Subject: Responses to Cygna Questions from the Independent Assessment Program  
Reviews  
Comanche Peak Steam Electric Station  
Independent Assessment Program - Phase 3  
Texas Utilities Generating Company  
Job No. 84042

COMANCHE PEAK STEAM ELECTRIC STATION  
CYGNA POTENTIAL FINDING REPORT  
(FISHER VALVES)  
REF: CPPA-39,734

COMANCHE PEAK STEAM ELECTRIC STATION  
CYGNA REVIEW QUESTIONS

TUGCO ANSWERS TO CYGNA'S QUESTIONS  
OF OETTER 84042.018, 10/1/84

Figure A1

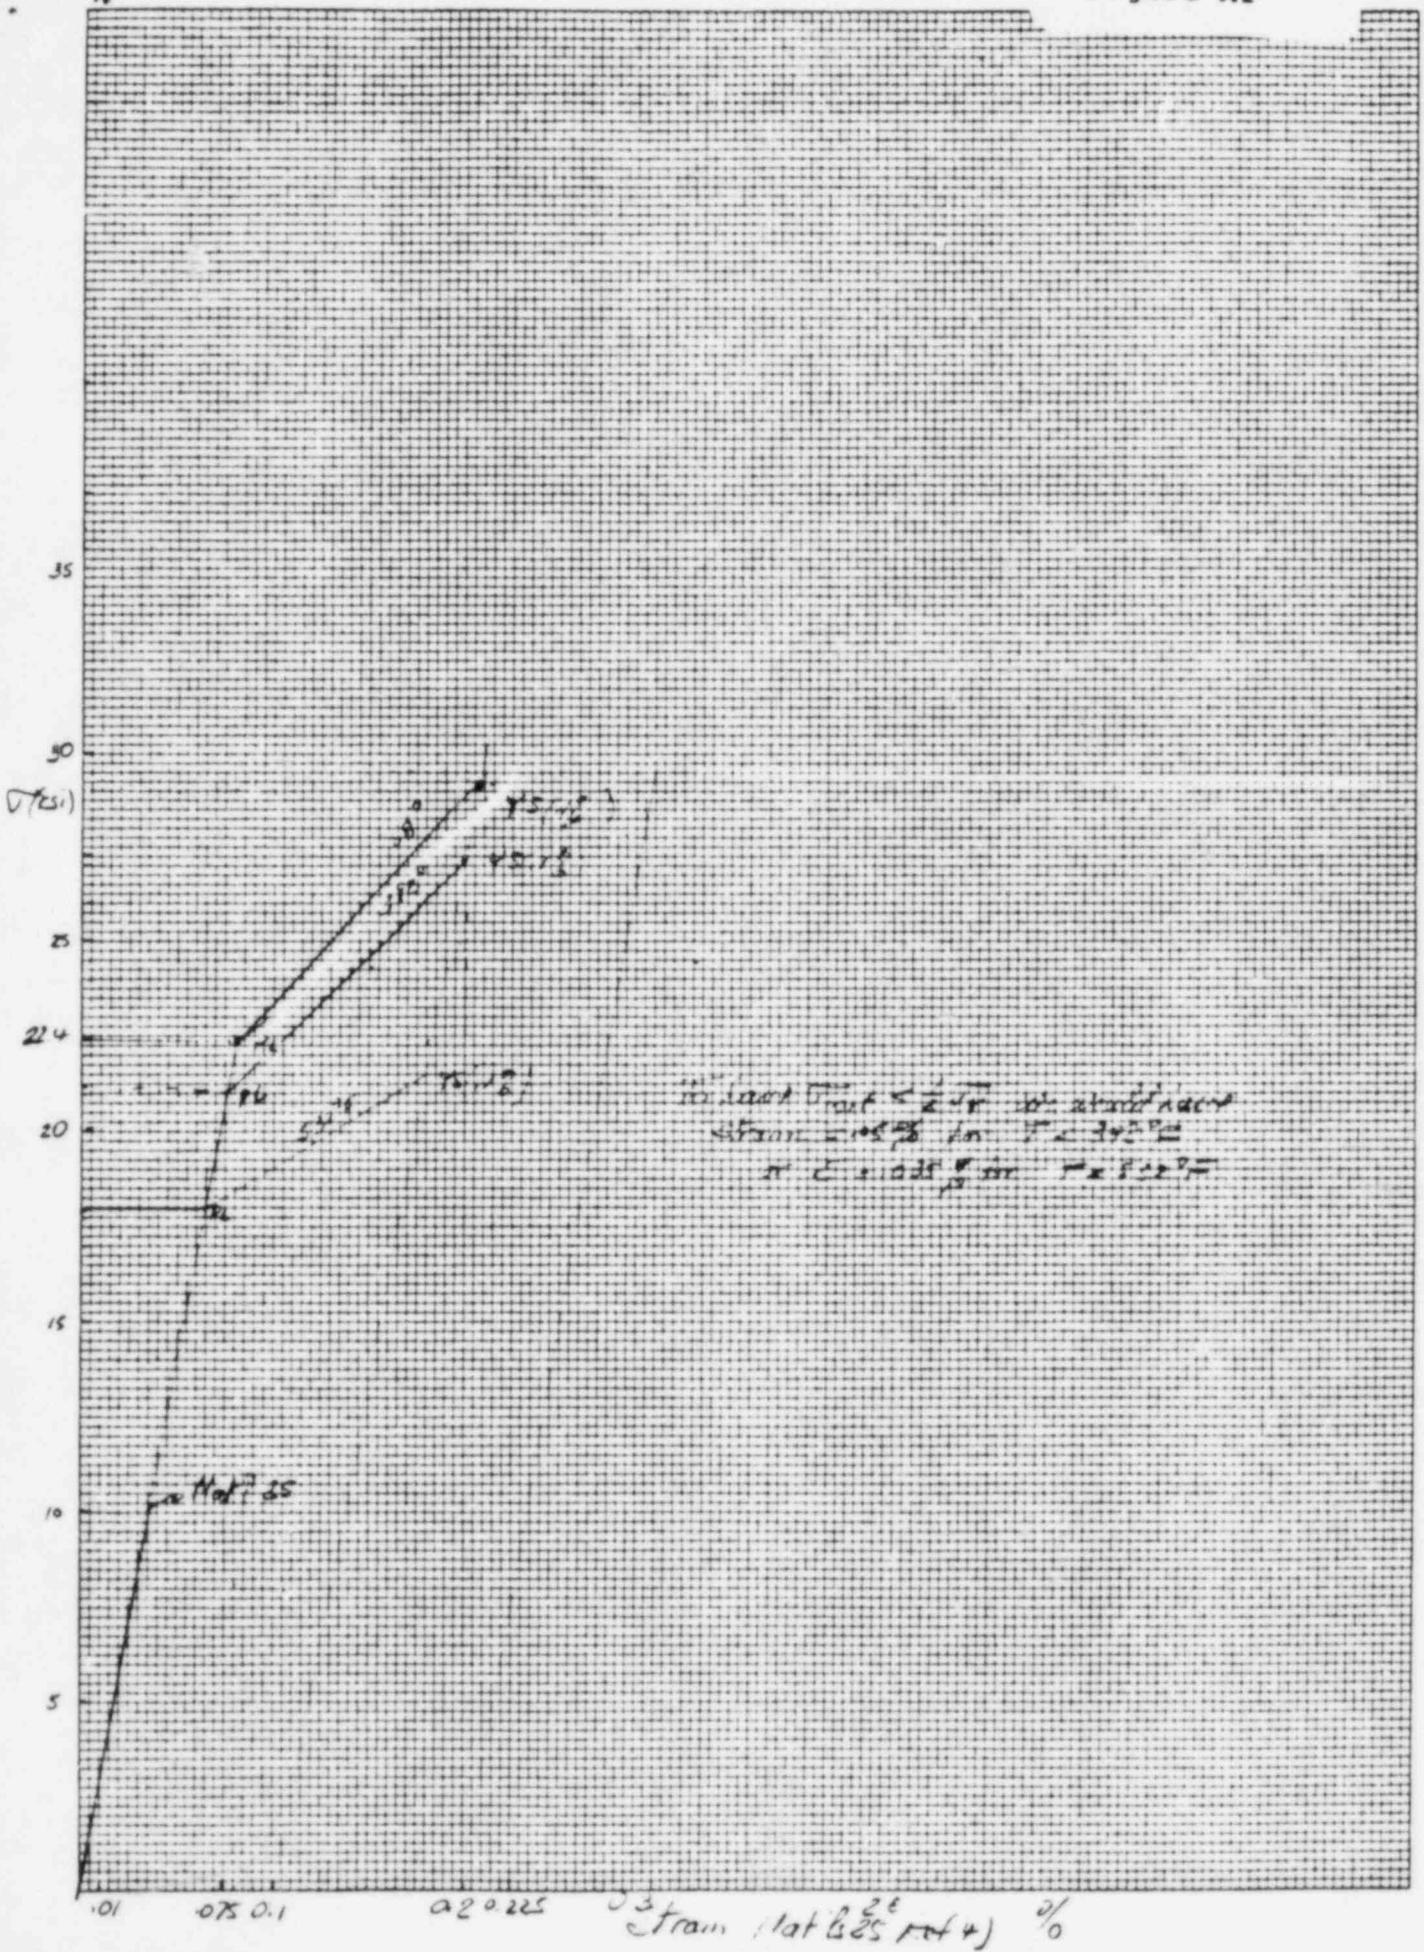
CYGNA has not received the A-36 steel stress relaxation graph and published report on stress relaxation (transcript page 77) nor a copy of TUGCO's answer to the NRC on this issue (transcript page 81). This information is necessary to complete our reviews.

of the chemical specifications. Figure A1 shows the stress strain curve of material 25 at various temperatures within our range of interest, i.e. less than 500°F. This curve is used to illustrate the meaning of material relaxation (as opposed to overall mechanical relaxation which will be discussed later) for monotonic loading, i.e. noncyclic. For the material to relax, plastic strain is required. Ferritic steels like A-36 exhibit a well defined proportional limit at which plastic strain begins. The yield strengths of these materials are given at the 0.1% or 0.2% elastic strain offset (in general it is the latter, although for material 25 the former is used). In figure A1 the details of the stress strain curve between the proportional limit and the yield point are not shown. From that figure, if the material is strained below the proportional limit no material relaxation will occur. Strains in excess of the proportional limit will result in relaxation, the amount of relaxation being proportional to the amount of plastic strain (or volume of material that has yielded). At room temperature the strain corresponding to the proportional limit is about 0.075 percent. At that level of initial strain, therefore, little or no relaxation should be expected. Figure A4, developed using the information on Material 25 of ASTM DS60, shows that the relaxation is negligible. At 532°F, the strain corresponding to the proportional limit point is 0.065 percent. Since the material 25 has been strained to .075% relaxation should be expected. Moreover, the heating of the material from room temperature to 532°F and the return to

FIGURE 1

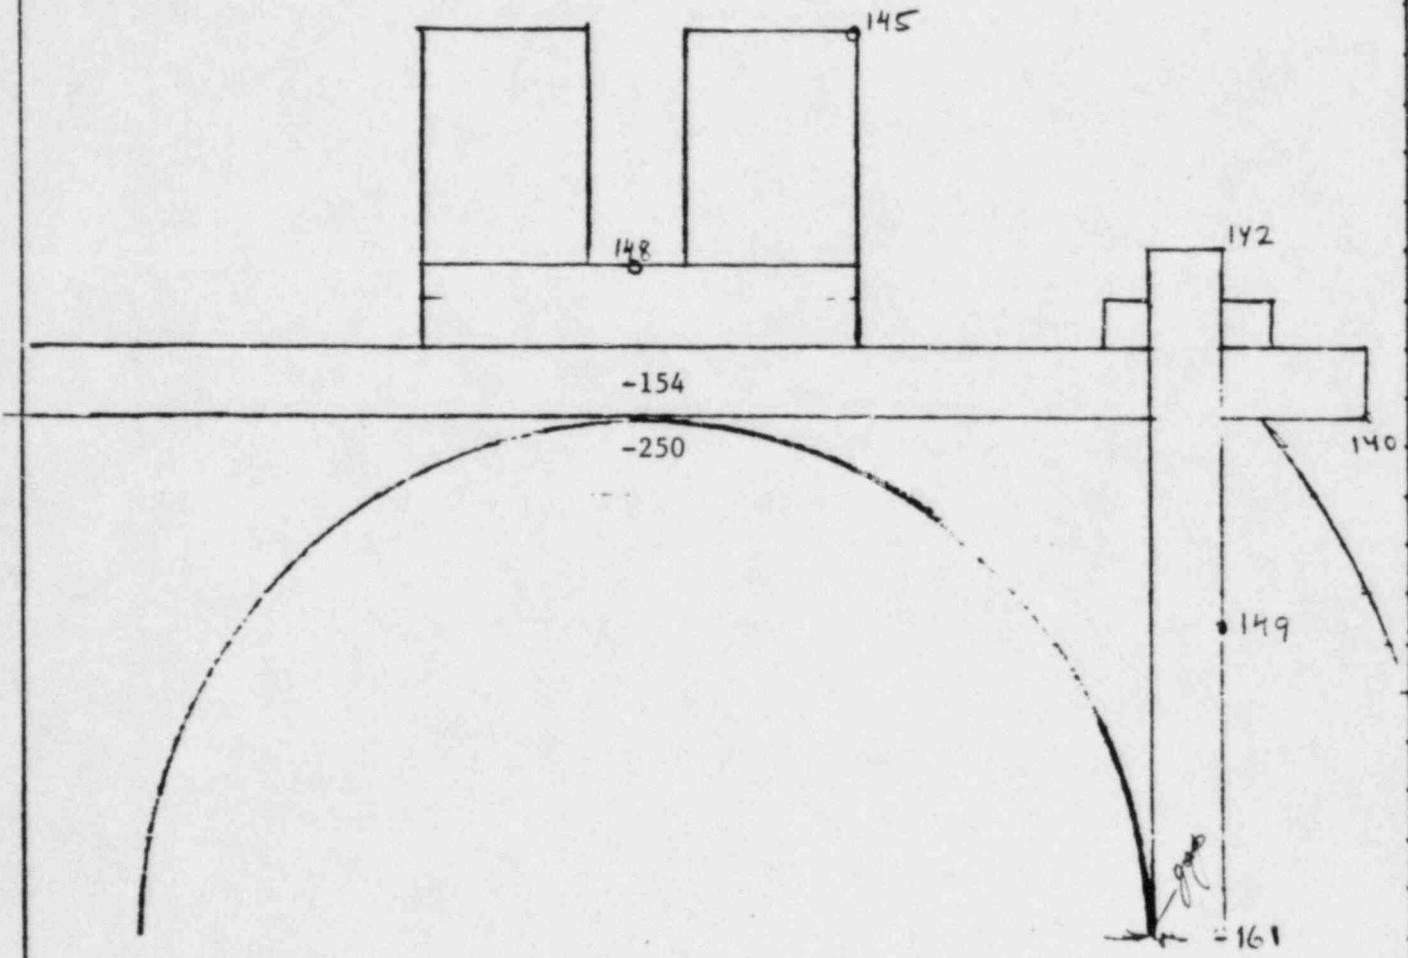
2. Q. CYGNA Question 4 (transcript page 32)  
Re: Use of 250°F for 10" Pipe

Results of the analyses are shown in Figure 1 for the uninsulated case. In Figure 2 similar results are shown for the insulated case. The only difference between the latter analyses and that of the uninsulated configuration are the pipe temperature, which in the latter instance is 350°F, and the presence of insulation.
